Memo To: File
From: T. Musick
Subject: Maxine Mine
Refuse Disposal and Reclamation Relative to
Mine Permit Application

TO: Those Receiving Copies
FROM: T. Musick
SUBJECT: Maxine Mine - Status of Refuse Sites

SUBJECT: MAXINE MINE--REFUSE DISPOSAL PROJECT

Figure 2 is a schematic illustrating the hydrologic assessment program (final well locations have not been established).

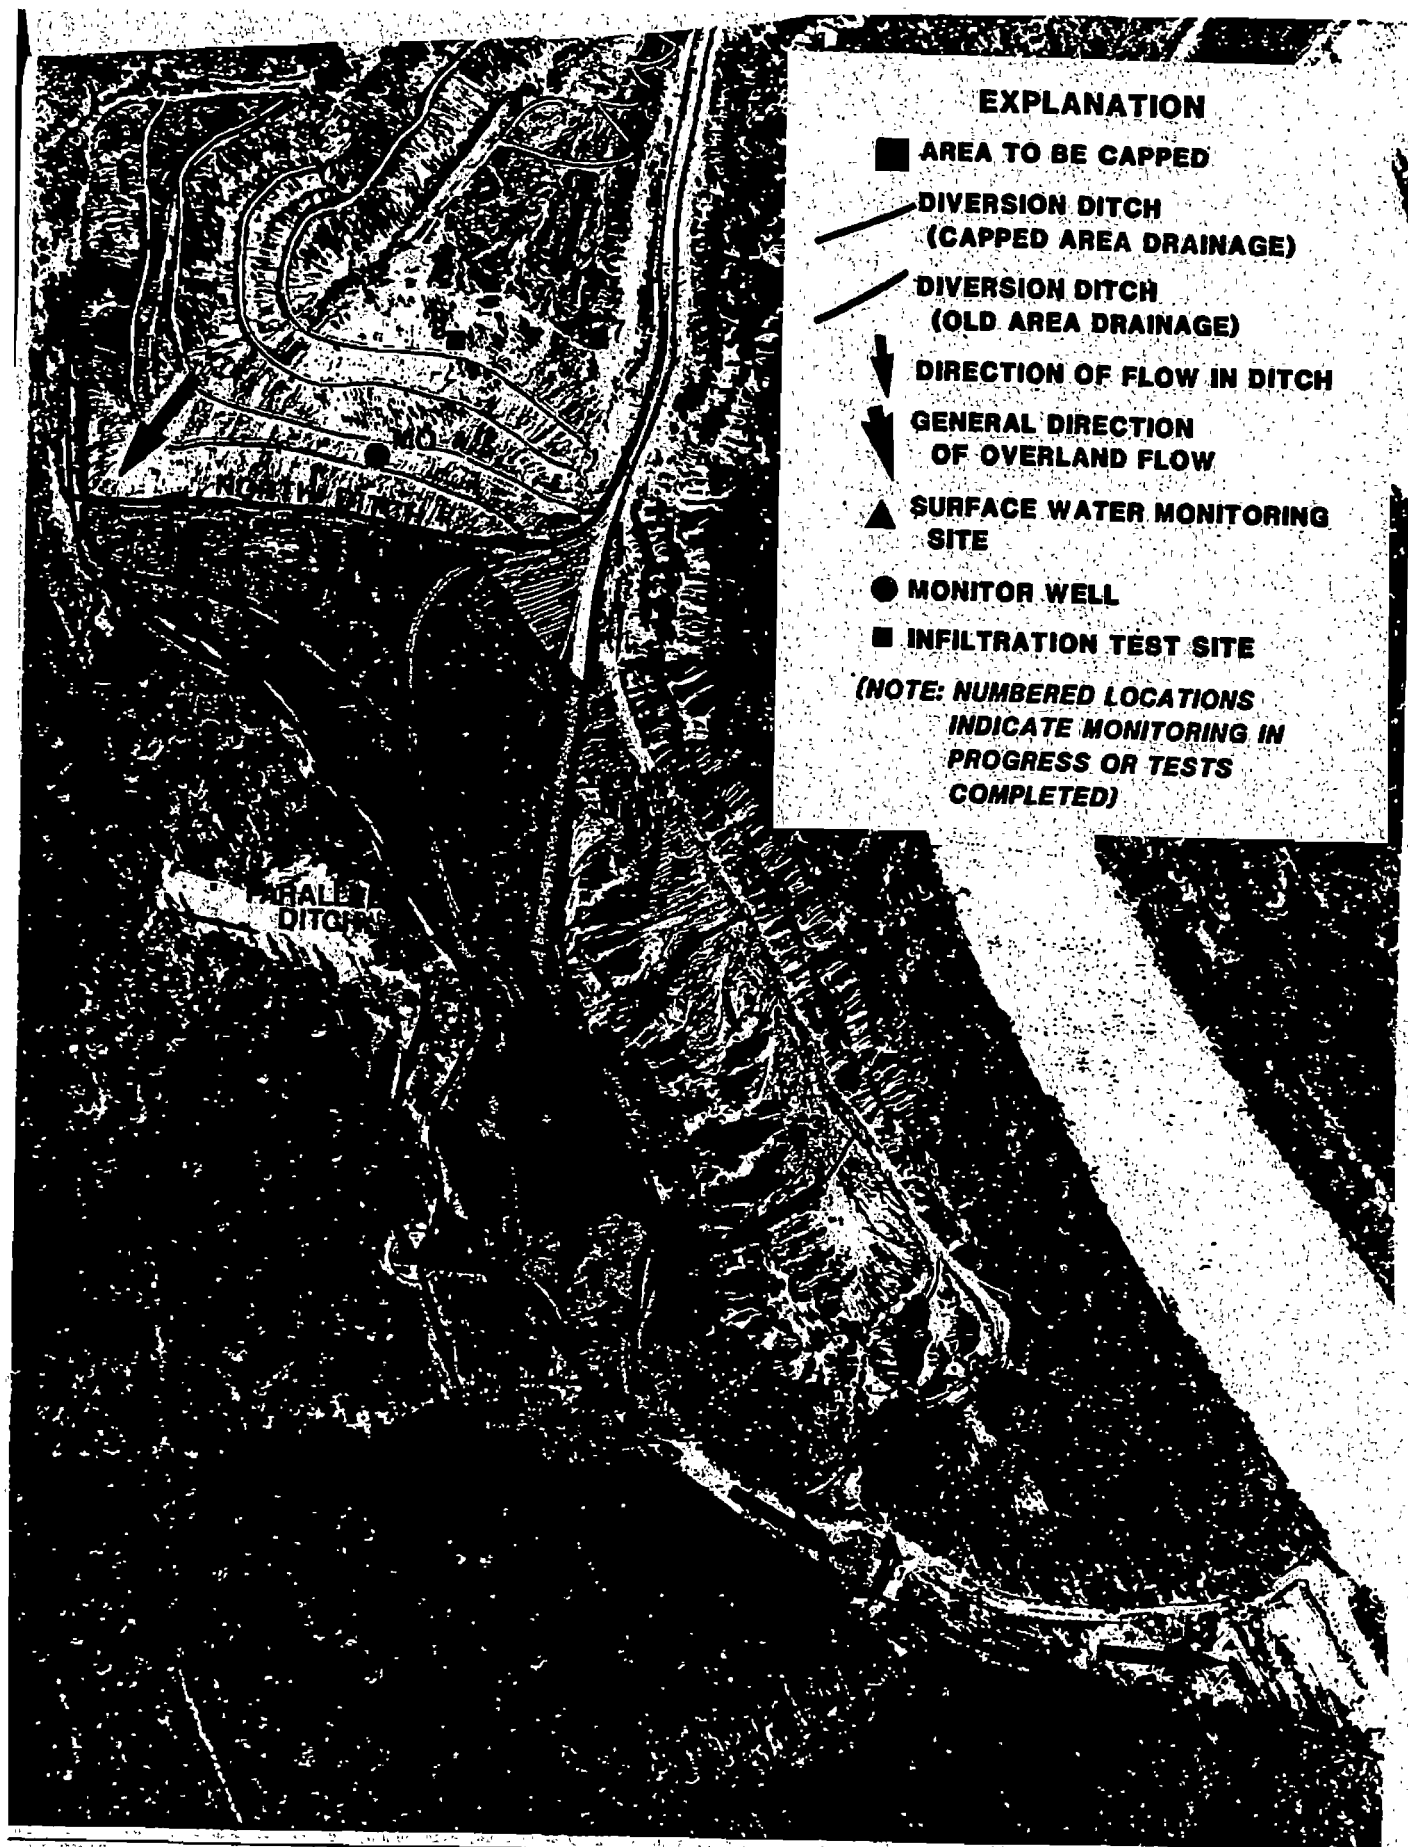
Surface-water monitoring program.

Establish and maintain diversion ditches to segregate run-off from old material and capped area, monitor and assess surface-water quality and flow.

Cross-over areas will be designed and constructed such that waters from the capped area cross over the ditch conveying waters from the old area.

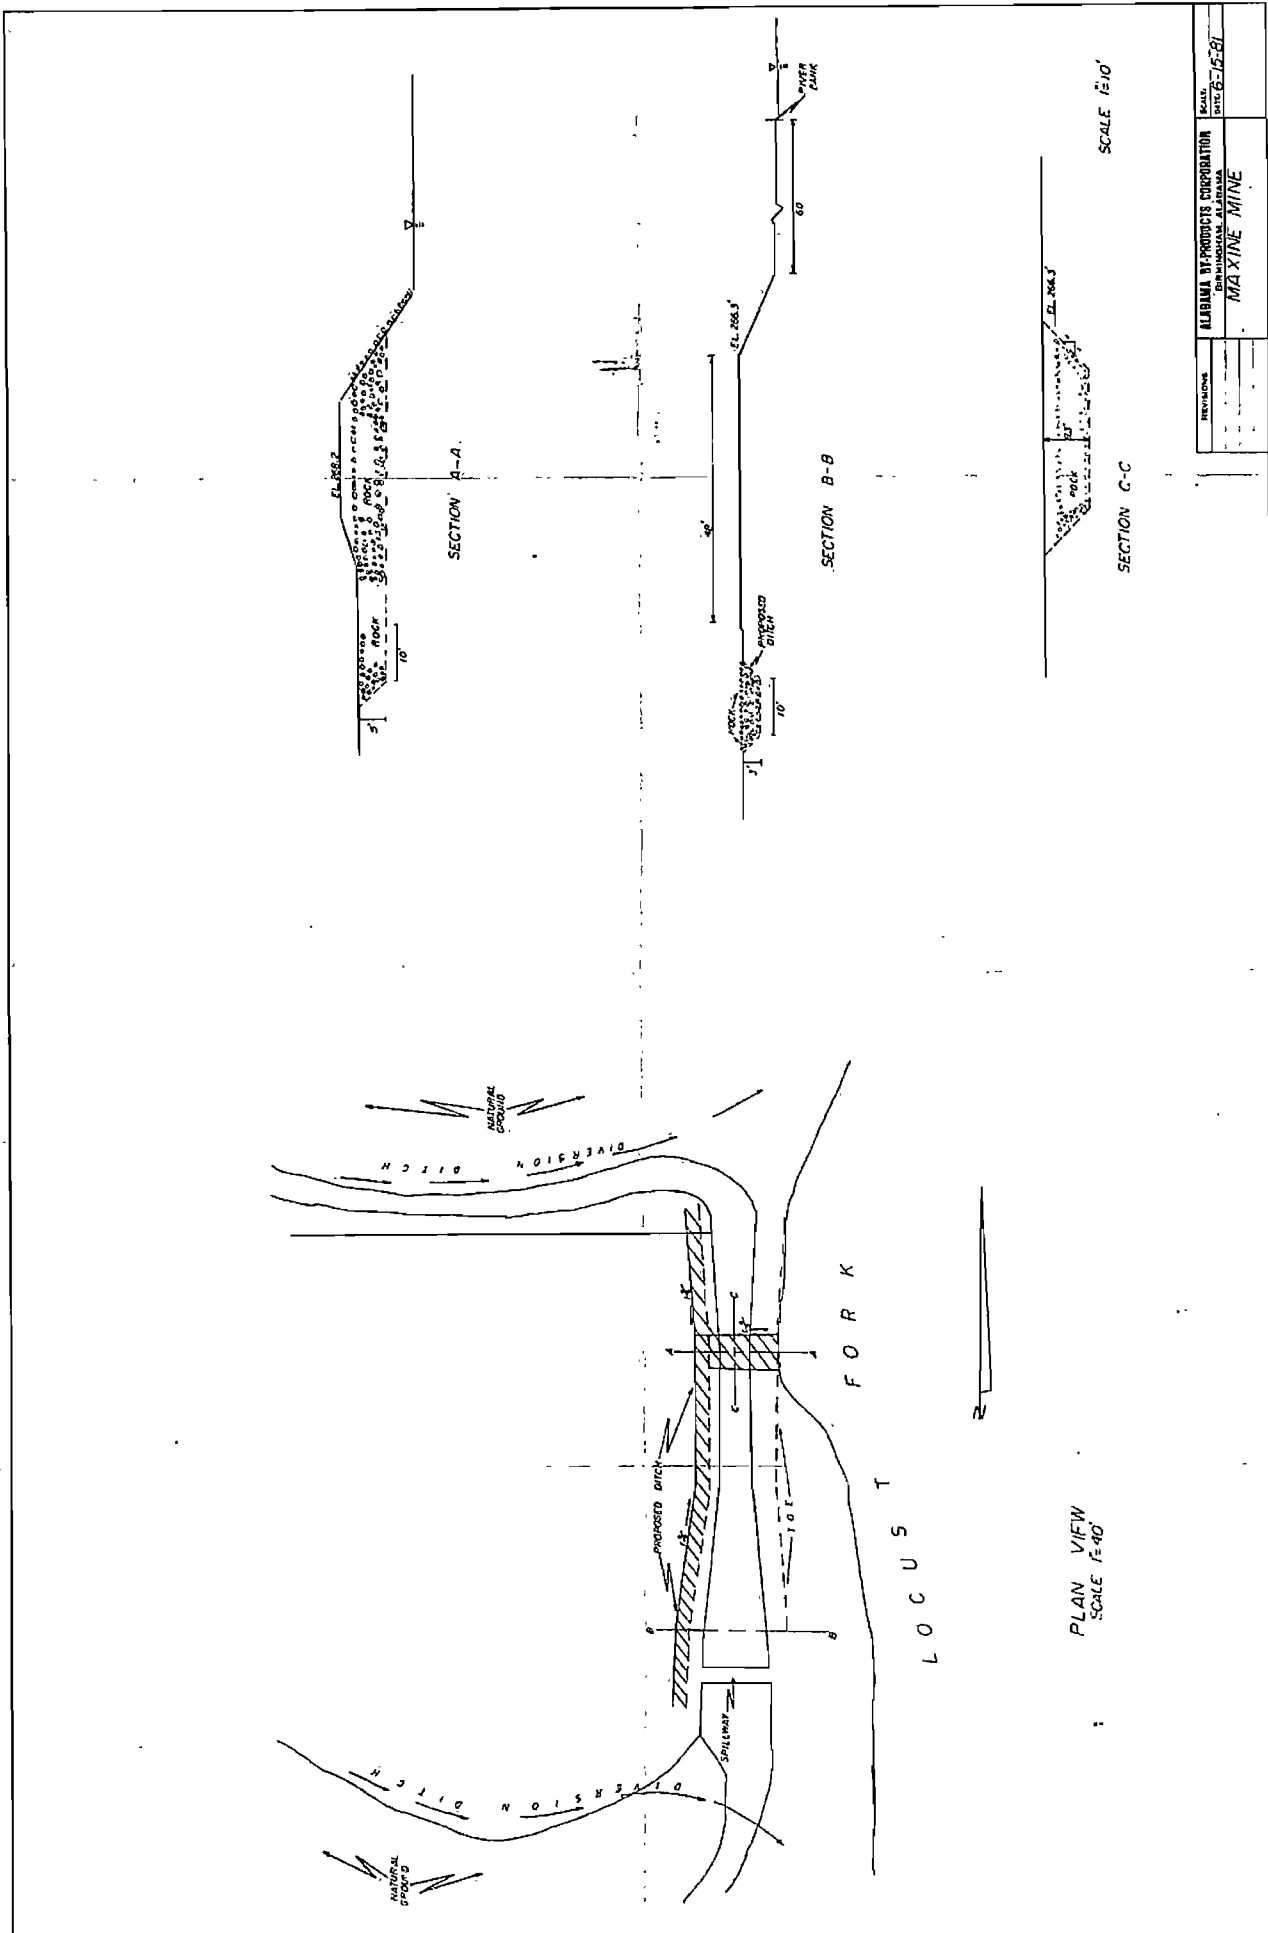
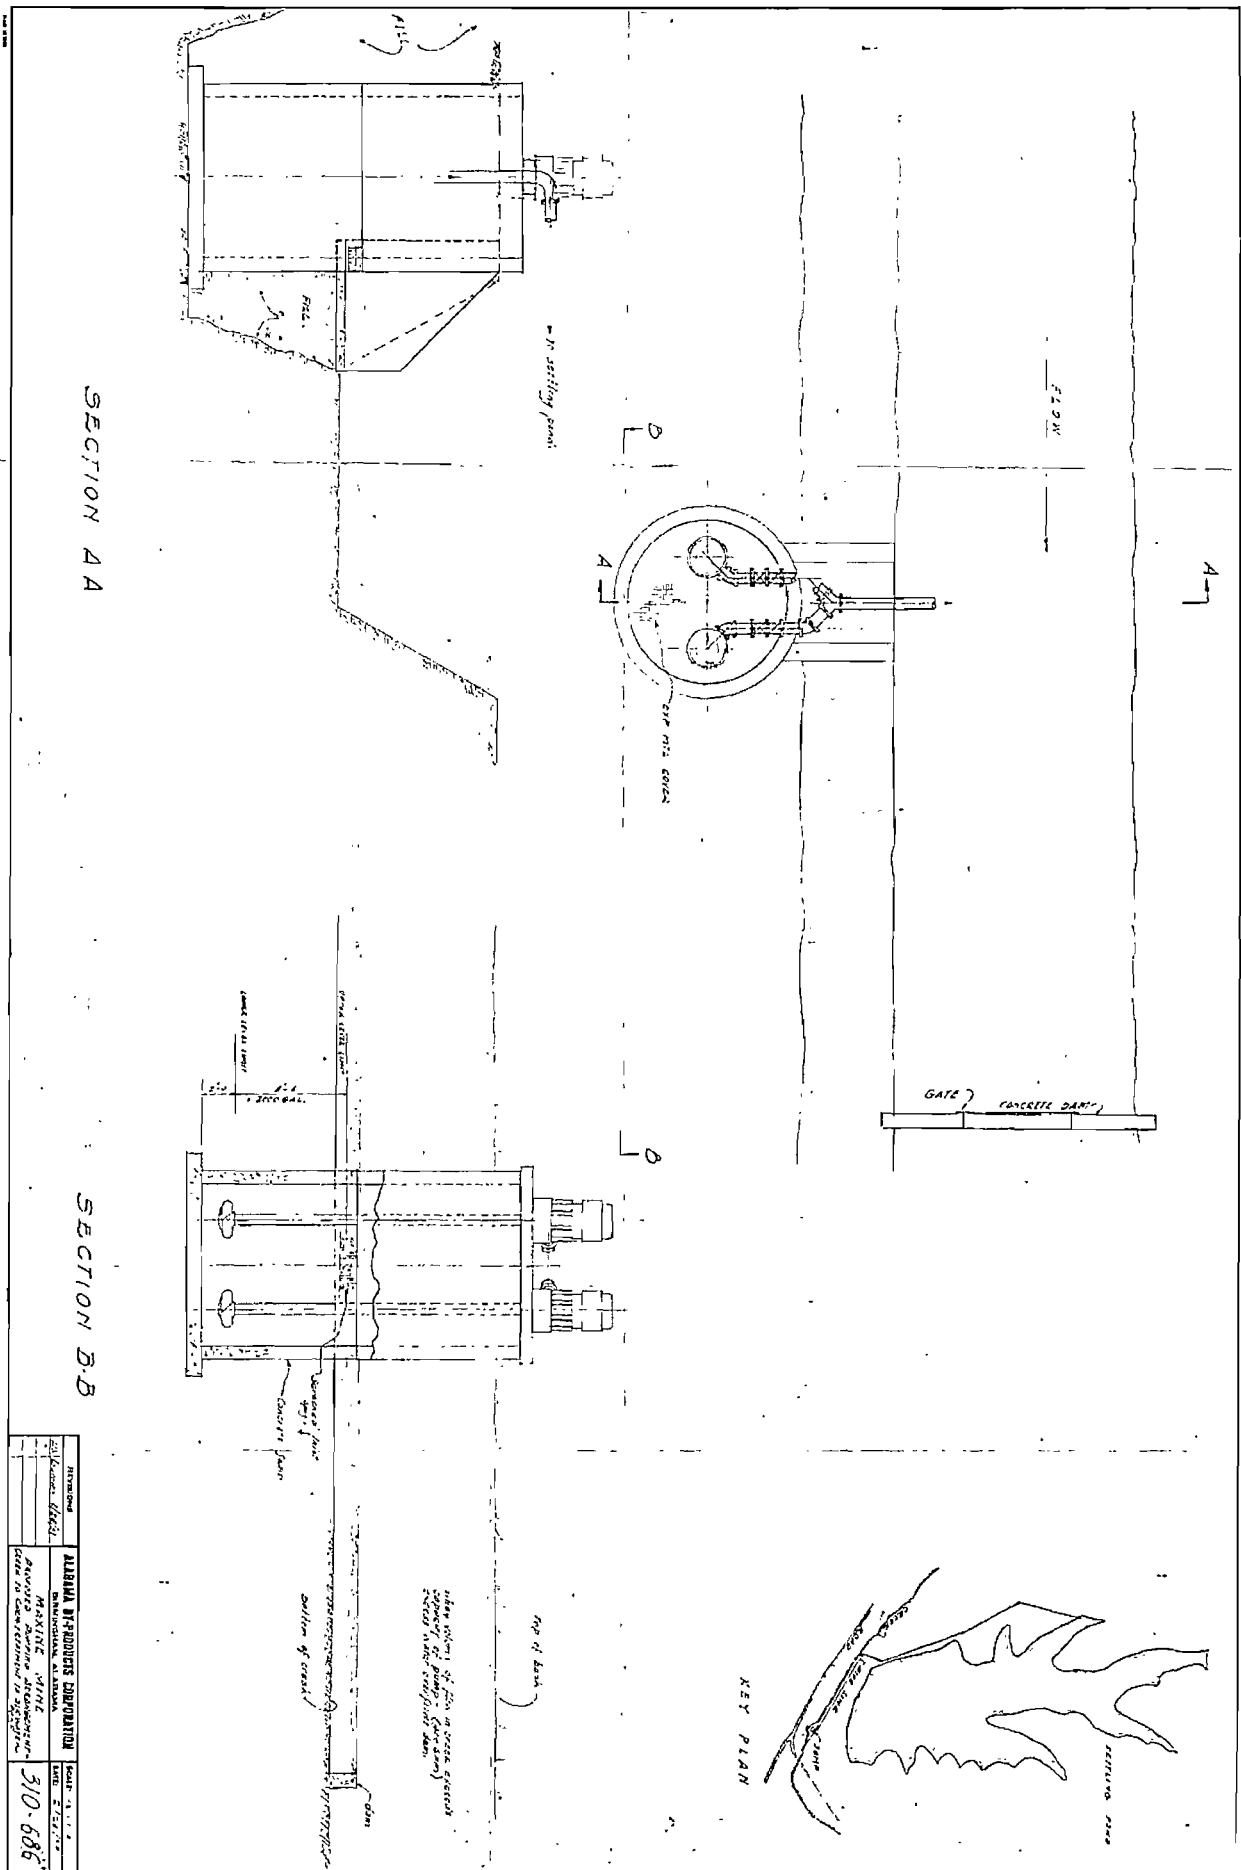
The plans being presented to you would consist of removing silt necessary for a drainage ditch shown on the attached drawing, extending the diversion channel to the river thus isolating the large storm runoff from the undisturbed area west of our refuse disposal site. We would then construct a diversion channel on the eastern side of the drainage course to again isolate undisturbed runoff water from that side.

The next step would be to put limestone in the drainage ditch of the lower silt structure coupled with a limestone filter adequately sized which would be approximately 25 feet wide x 60 feet long to accommodate the runoff of excess water.

We are in receipt of your plan for pollution abatement at the Maxine Mine Rock Refuse Dump. Based upon a review of the material and an on-site survey, the plan has been approved.
